Planning Inspectorate Ref: EN010114

The Keadby 3 (Low Carbon Gas Fired Generating Station) Order

Preliminary Environmental Information Report Addendum

> Applicant: Keadby Generation Limited Date: March 2021

Figure 3.1

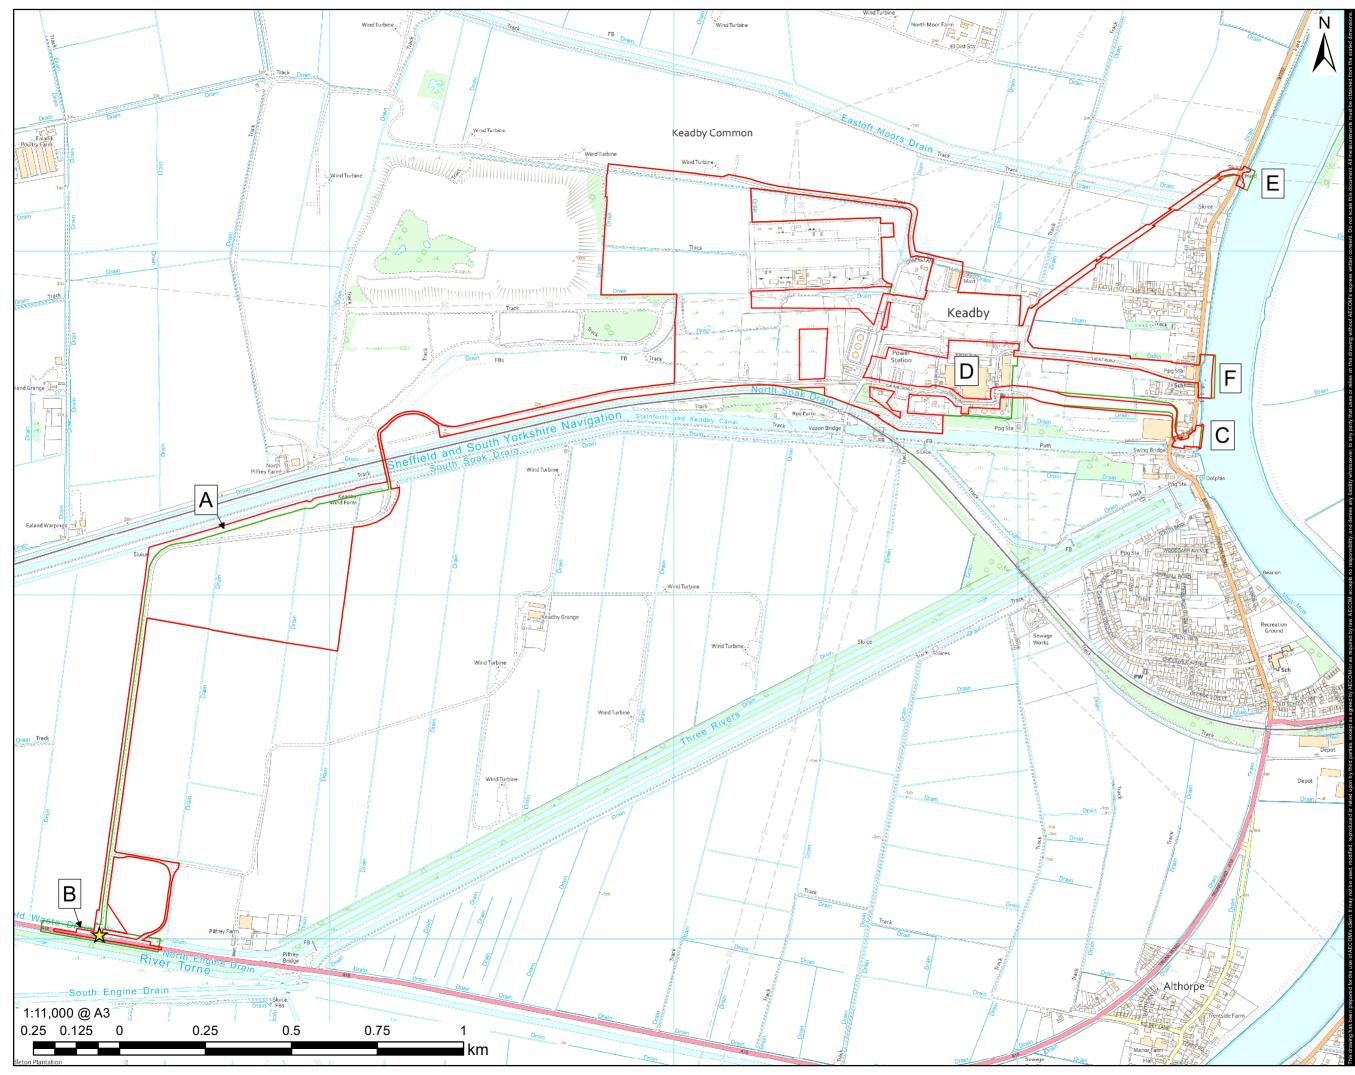
- 2.1.6 The areas of the Proposed Development Site that have been subject to change are described with respect to **Figure 3.1** and **Figure 3.2** at the end of this report.

- **A** Additional Area for Landscaping and Biodiversity Enhancement:
 - Indicative Order Limits expanded by 2.31ha to provide additional land which is proposed for landscaping and biodiversity provision. This comprises an area of existing road verge along the site access road and additional areas of improved grassland south of the South Soak Drain and the Stainforth and Keadby Canal for landscaping and biodiversity provision. The road verge is in parts bounded by existing immature hedgerow. Areas to the south of the canal comprise species poor improved grassland interspersed by field drains. These additional areas are within the Applicant's ownership.

- B Additions and Reductions in Area for the A18 Junction Improvement Option:
 - Indicative Order Limits expanded along the A18 to cover refined works areas at the road junction and for the replacement of the existing Mabey Bridge; however, the majority of the land in this area has been removed from the PEI Report Order Limits; and

- Indicative Order Limits expanded by 0.06ha adjacent to Mabey Bridge to allow additional land for construction laydown (shown as Keadby 3 Construction Laydown Area on Figure 3.3) and subsequent biodiversity provision.

- **C** Additional Oversail Area in River Trent, Additional Area for Highway and Repositioned Private Additional AIL Route:
 - Indicative Order Limits extended at the Waterborne Transport Offloading Area to cover 5m oversail into the River Trent to allow for a larger crane located on the quayside, used for offloading AIL during construction. This has resulted in an expansion of the indicative Order Limits at this location by 0.04ha;

- Indicative Order Limits extended at the Waterborne Transport Offloading Area onto Trentside by <0.01ha to cover fully the existing access easement, in order to facilitate works to access if necessary; and

- Indicative Order Limits refined at the Additional AIL Route to align with the routing plan of the proposed Keadby 2 Power Station AIL routing consented through North Lincolnshire Council planning application PA/2019/1595.

- **D** Reduced Area within Keadby 1 and Keadby 2 Power Stations:
 - Indicative Order Limits refined to remove the majority of land within the existing Keadby 1 Power Station that had previously been under technical evaluation for water connections, including sections of Chapel Lane.

- **E** Reduced Area of Water Discharge Corridor:
 - Indicative Order Limits refined to reduce area considered in the PEI Report Indicative Order Limits, removing areas within the River Trent.

- **F** Reduced Area of River Water Abstraction Option:
 - Indicative Order Limits refined to reduce area considered in the PEI Report Indicative Order Limits following refinement of assumptions for the temporary cofferdam that could be required, should the River Water Abstraction Option be pursued in the event that the Canal Water Abstraction Option is not feasible.
